**VALENTINE GOLD PROJECT: AMENDMENT TO THE ENVIRONMENTAL IMPACT STATEMENT**

**PART 2**  
**Responses to Regulatory and Public Comments**

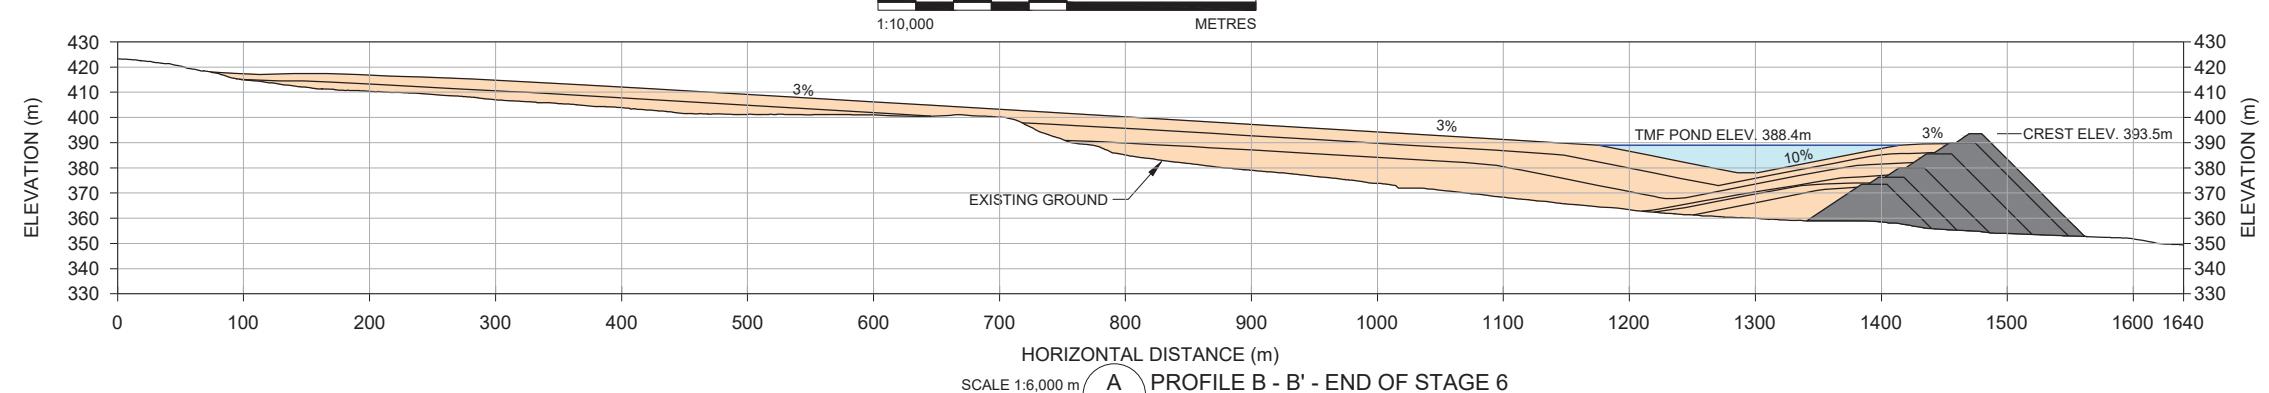
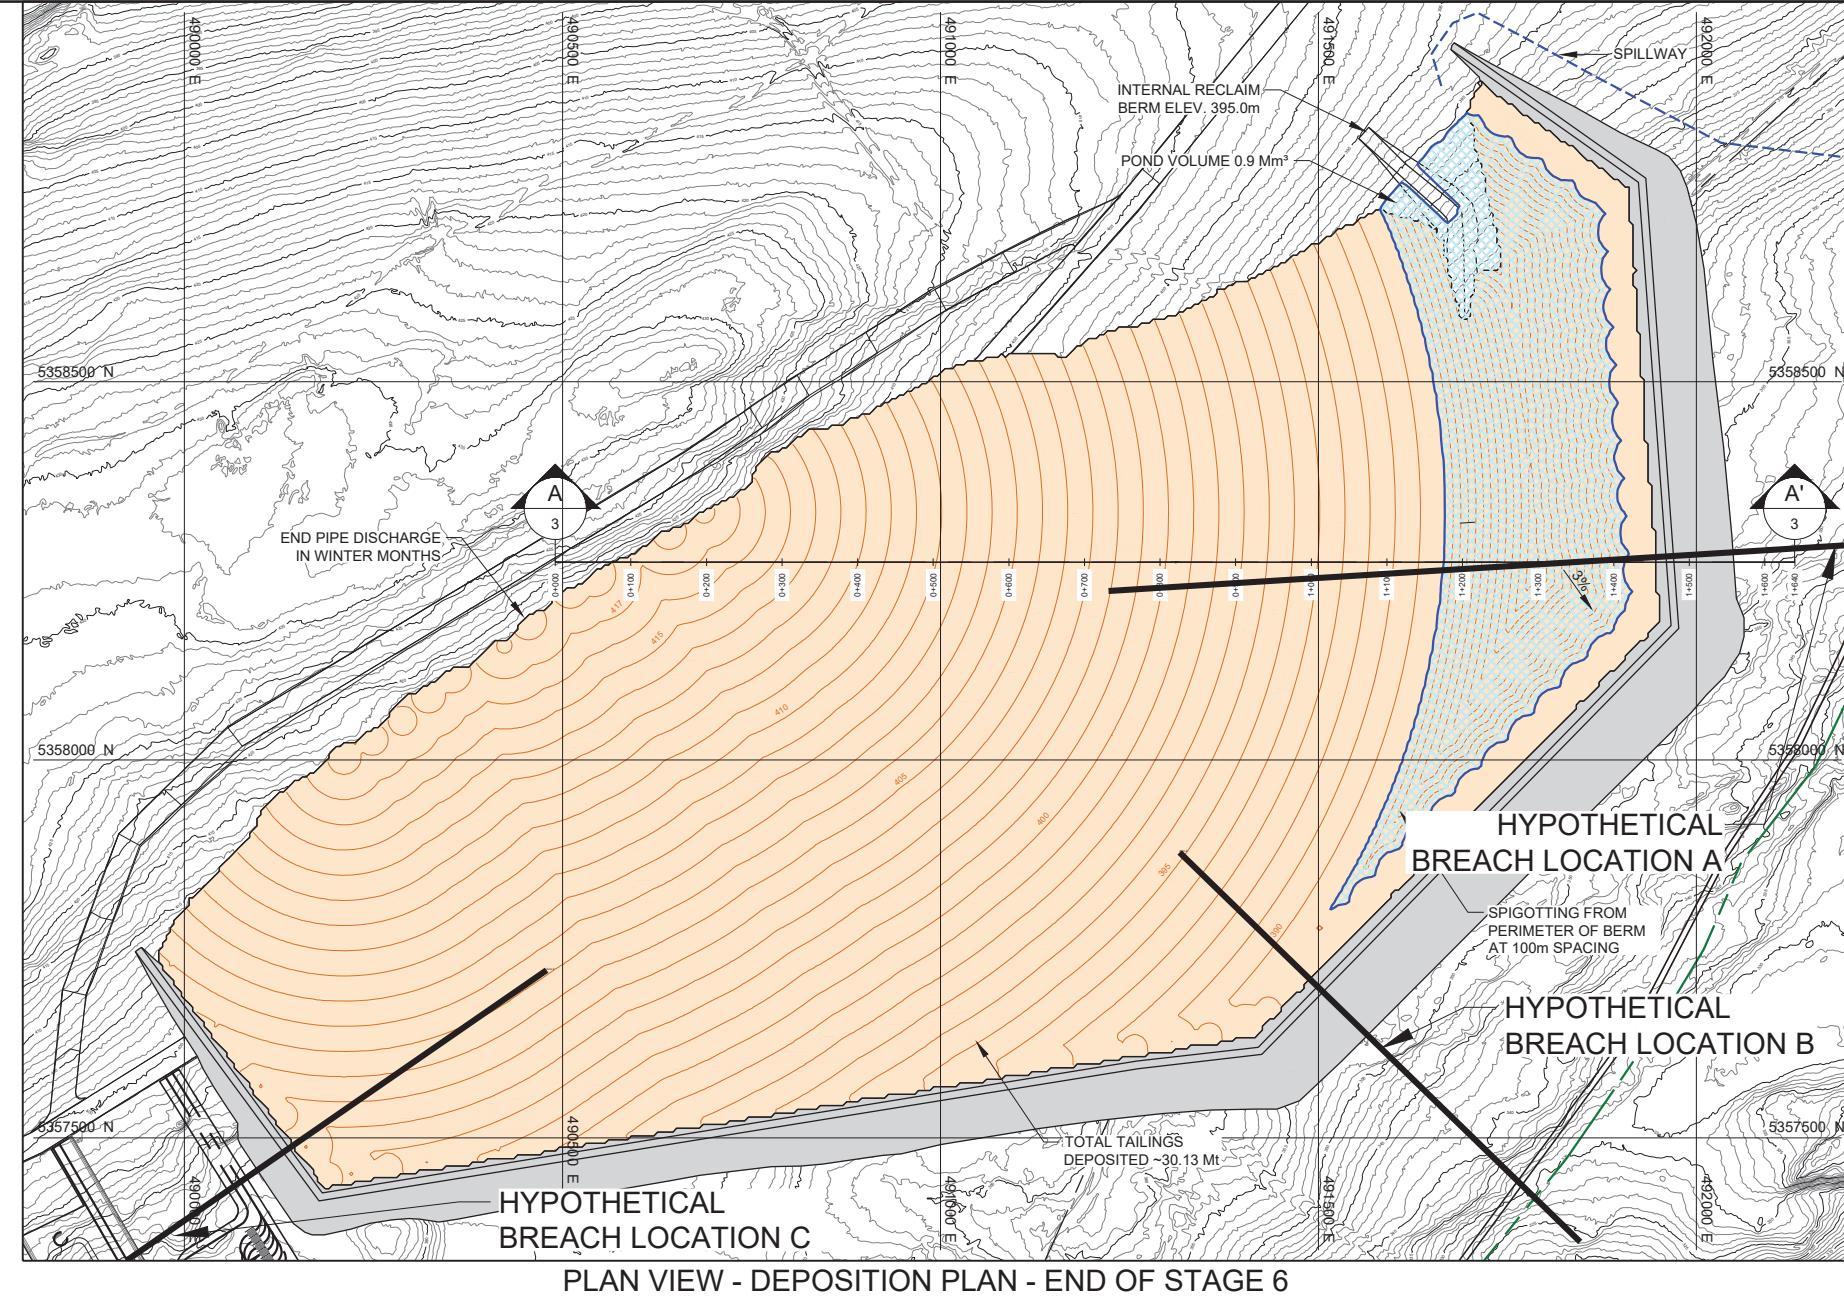
ID:	ECC-17
Expert Department or Group:	Department of Environment and Climate Change- Water Resources Management Division
Guideline Reference:	Section 4.2.1.1- Dam Safety
EIS Reference:	BSA1
Context and Rationale:	-
Information Request:	BSA1 refers to the TMF dam as having East Dam, South Dam and West Dam. There is no figure indicating which portions of the TMF are what dam.

Response:	<p>The East, South and West Dam naming convention was previously used in the Dam Breach Assessment (DBA) to identify the locations selected to be breached as a part of the DBA; the East Dam referred to the approximate area from chainage 2+500 to the 3+350, the South Dam from 0+500 to 2+400 and the West Dam from 0+000 to 0+400 (Figure ECC-06.1). However, this naming convention is no longer used. The specific breach locations are now referred to as locations A, B and C as shown in Figure ECC-17.1. These locations were selected for the following reasons:</p> <ul style="list-style-type: none"><li>• Location A: allows for the peak release of the tailings management facility (TMF) pond (water and tailings followed by liquefied tailings beneath the pond)</li><li>• Location B: is the location with the maximum tailings deposition depth; additionally, a release at this location has the largest potential impact on the Victoria Dam</li><li>• Location C: a breach in this location would have the largest potential impact on plant site infrastructure and personnel</li></ul>

OBJECT NO. CONTROL REV. FIGURE  
0350991 0001 0 ECC-22.1

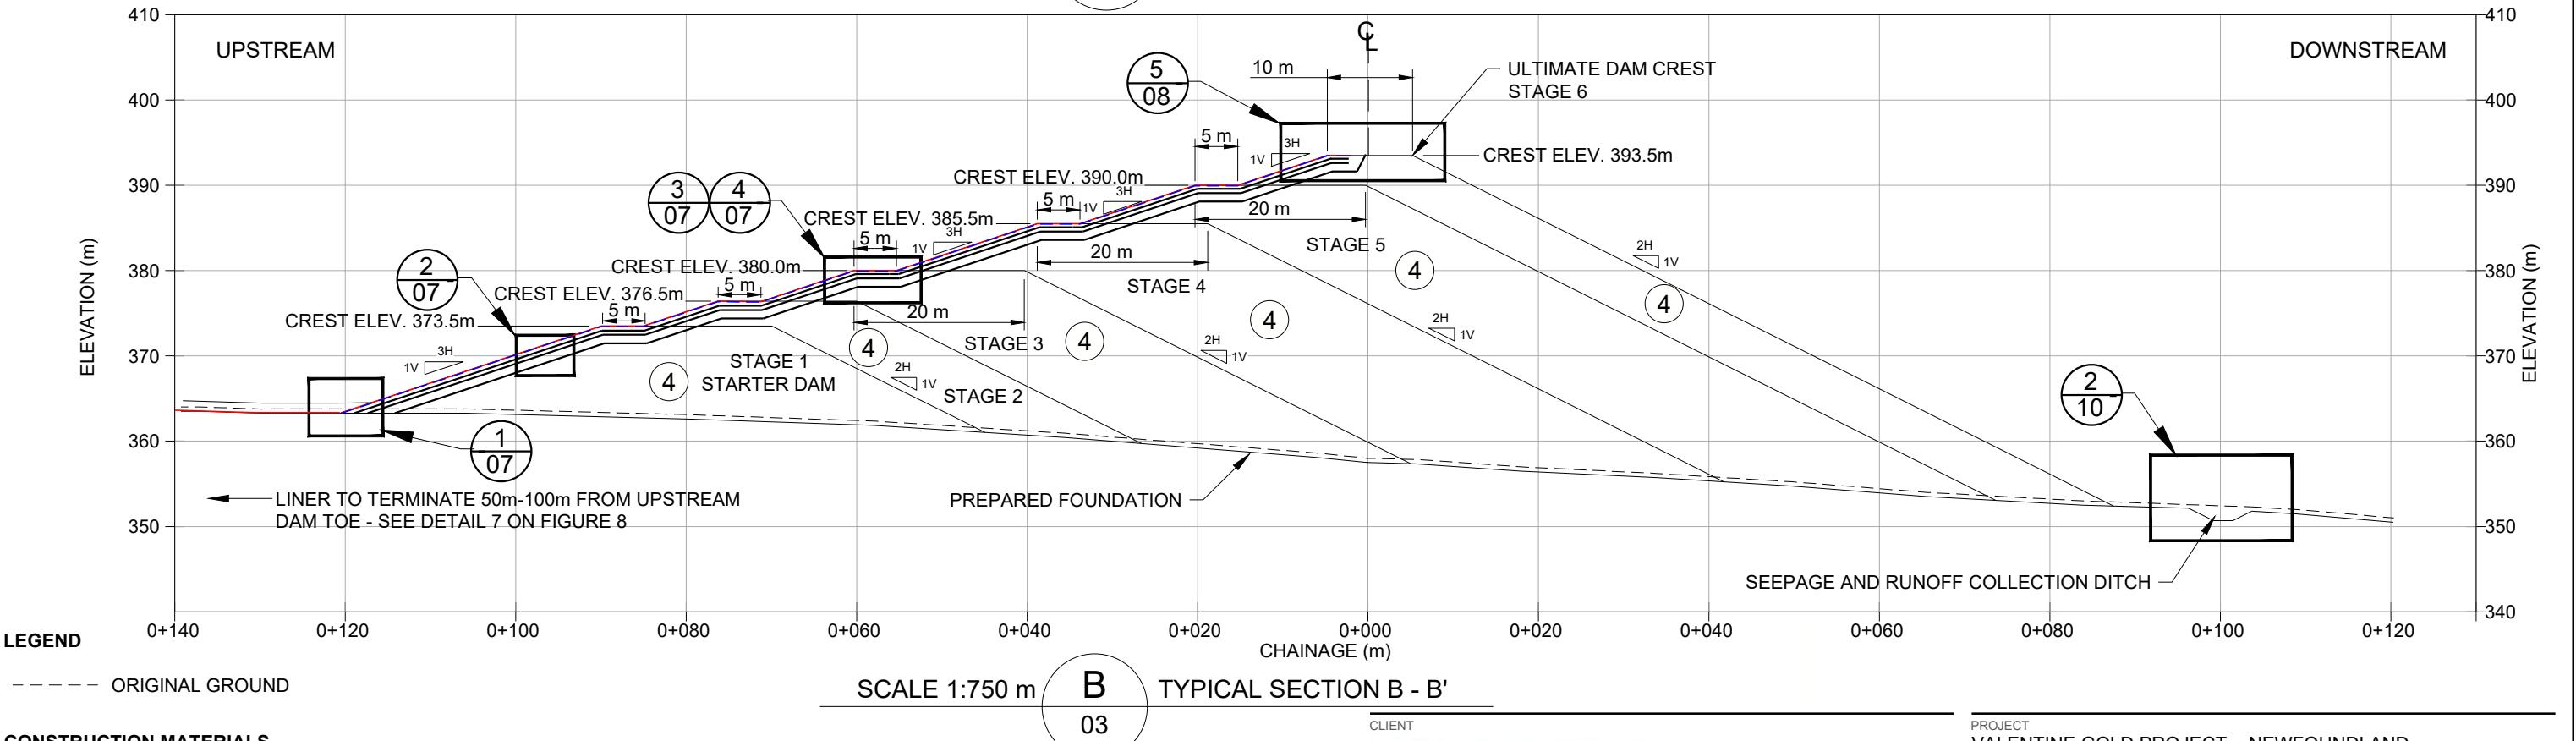
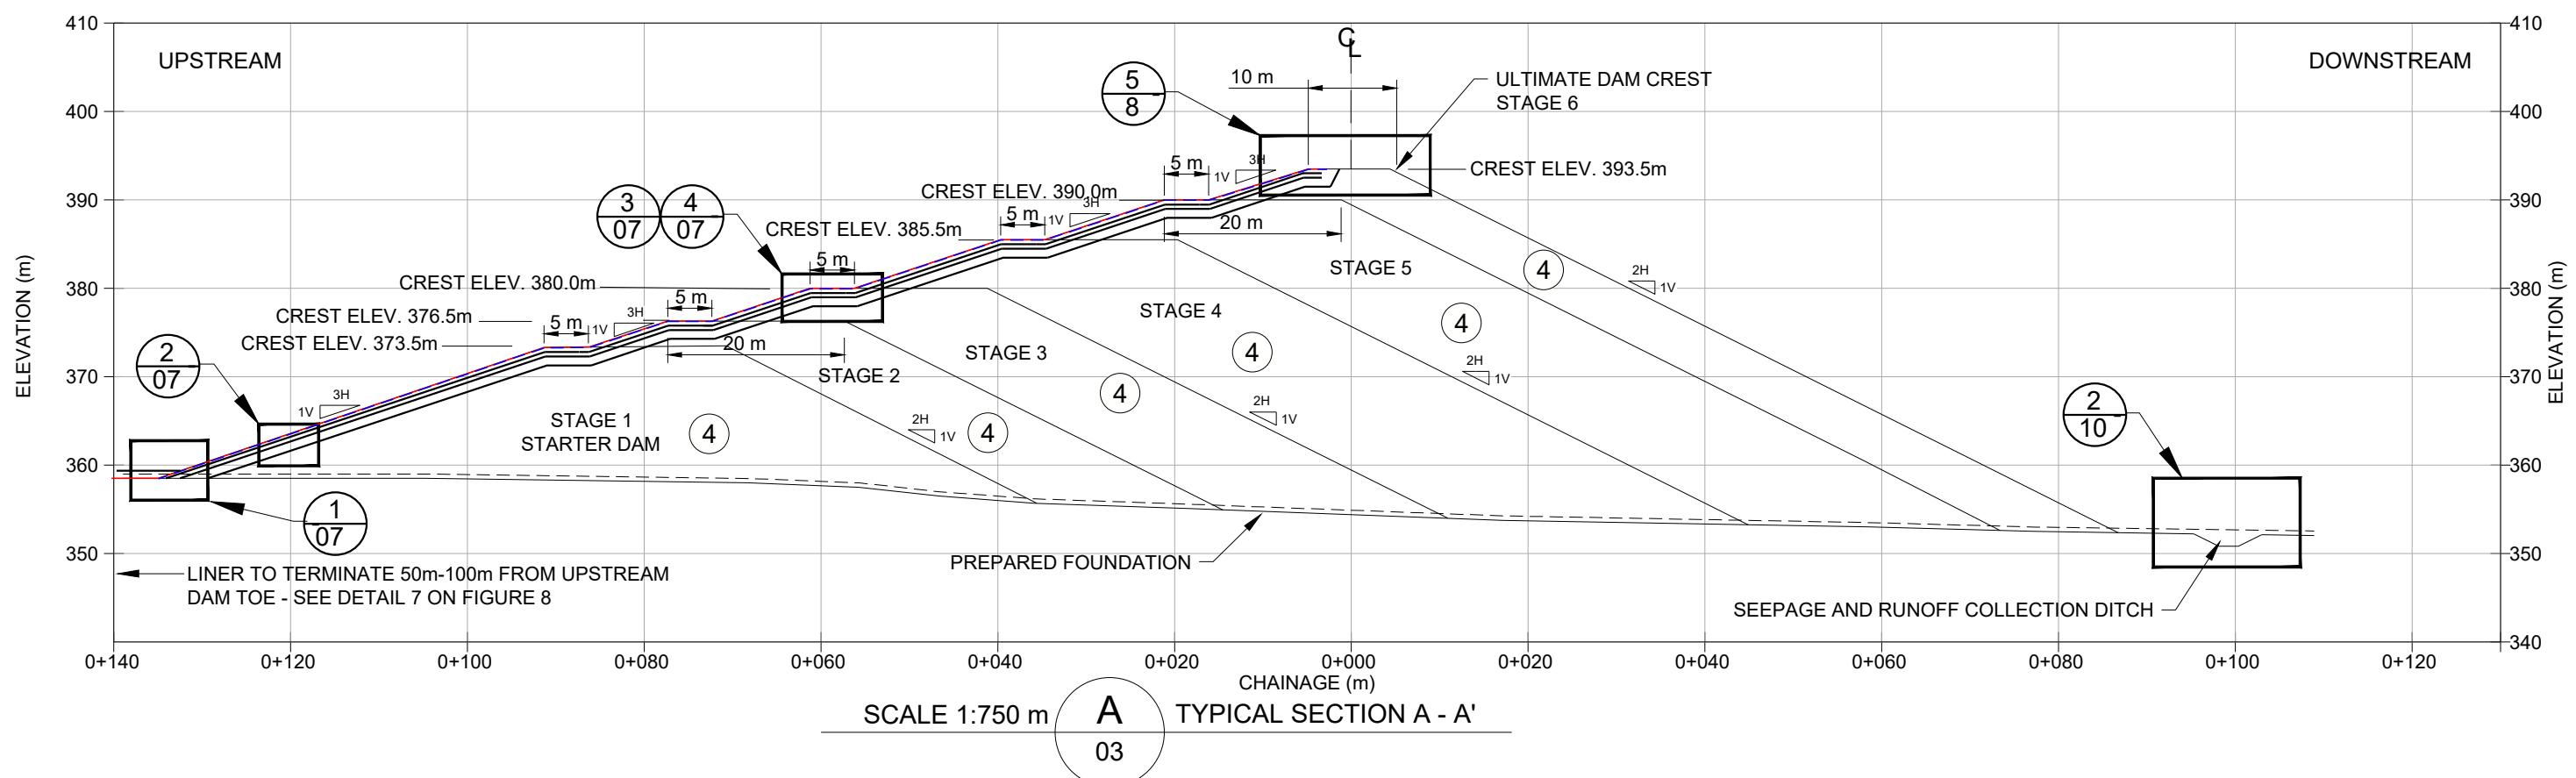
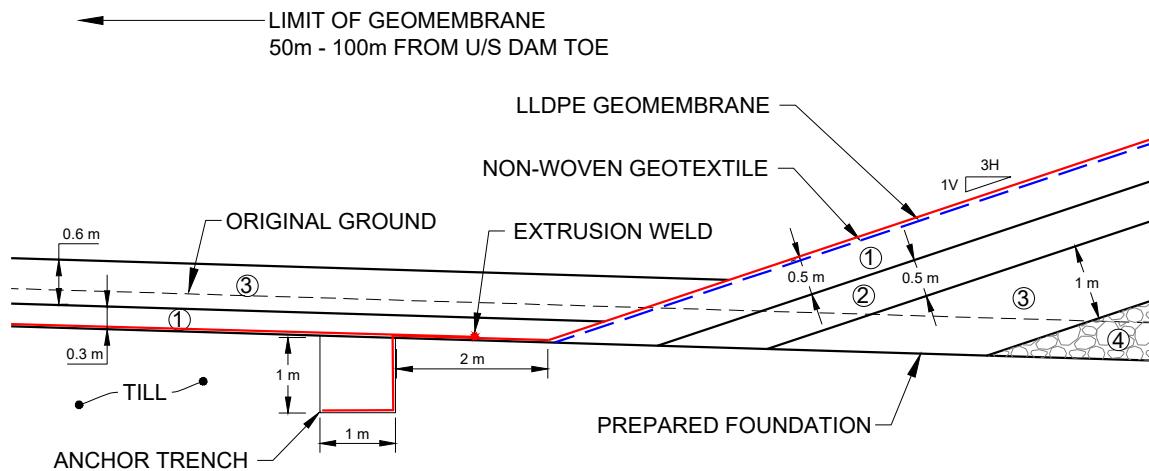
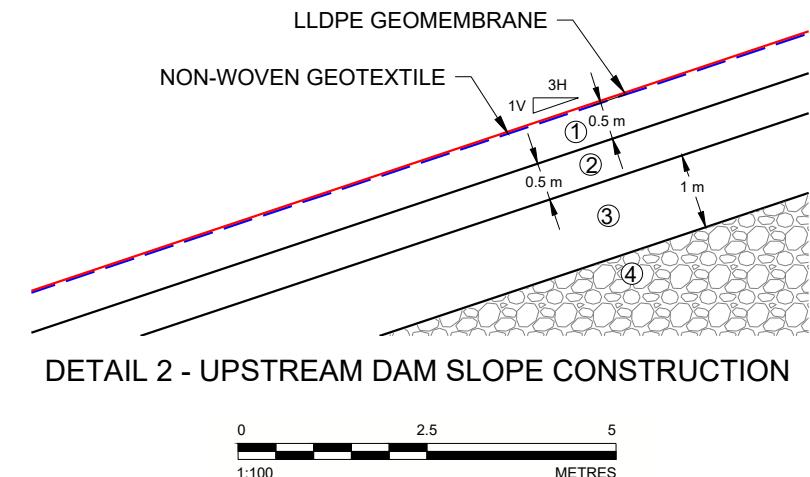
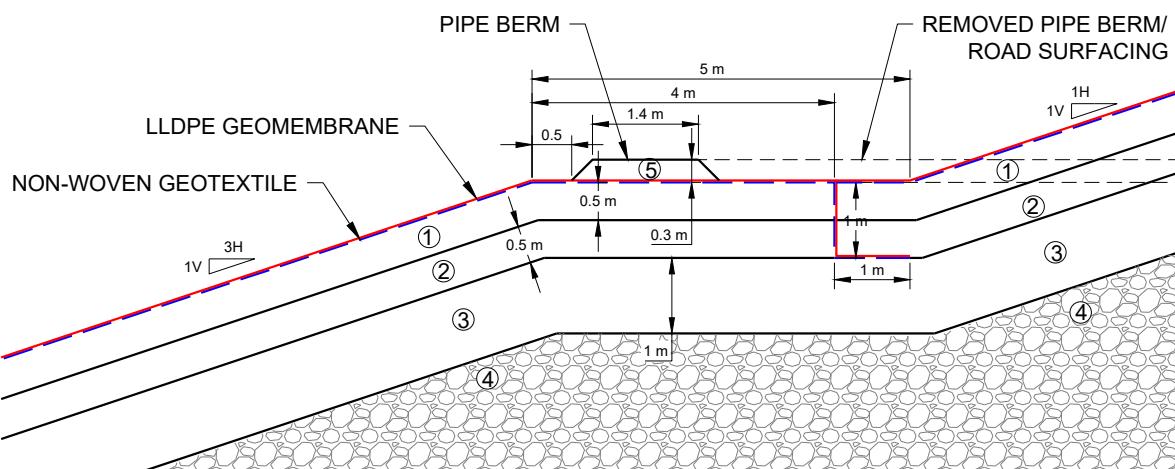
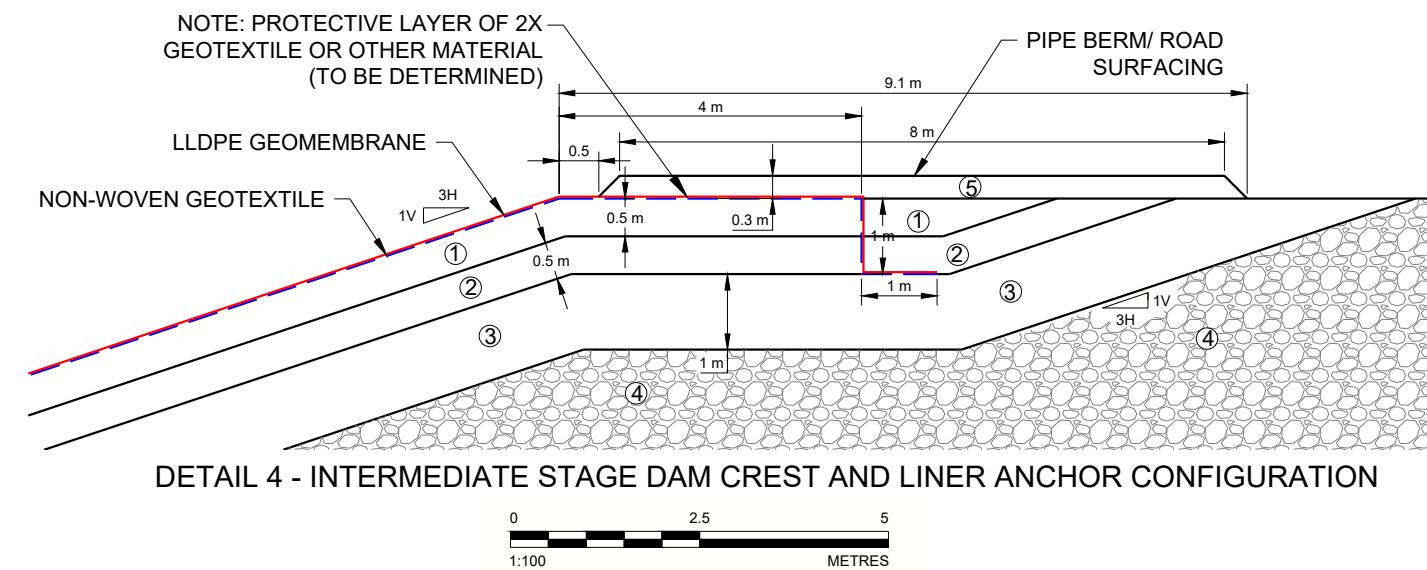
<b>ID:</b>	<b>ECC-22</b>
Expert Department or Group:	Department of Environment and Climate Change- Water Resources Management Division
Guideline Reference:	Section 4.2.1.1- Dam Safety
EIS Reference:	-
Context and Rationale:	Section 2.3.4.1, pg. 2.58 “A geomembrane liner will be incorporated into the upstream slope of the embankment to retain water within the impoundment.”
Information Request:	Will the liner extend the entire 3km length of the dam? Figure 2-44, pg. 2.106  A 1 m thick coarse filter zone is indicated along the upstream embankment face of the tailings dam immediately beneath the sand bedding/liner. Will this filter layer extend to the downstream toe of the dam? The drawing cuts this off.

Response:	The upstream slope face of the dam at all stages is lined with Linear Low Density Polyethylene (LLDPE) geomembrane along the entire dam alignment (length). Furthermore, the geomembrane will be extended as a blanket along the foundation 50 to 100 m upstream of the dam toe as a seepage mitigation measure. This will improve dam safety by increasing the seepage pathway length and reducing the critical gradients at the dam toe. The filter zone extends to the crest of the ultimate dam (stage 6), not along the downstream face of the dam, as it is only required for the placement of the liner system. See figures ECC-22.1 to ECC-22.3 illustrating the dam design details.
Appendix:	None
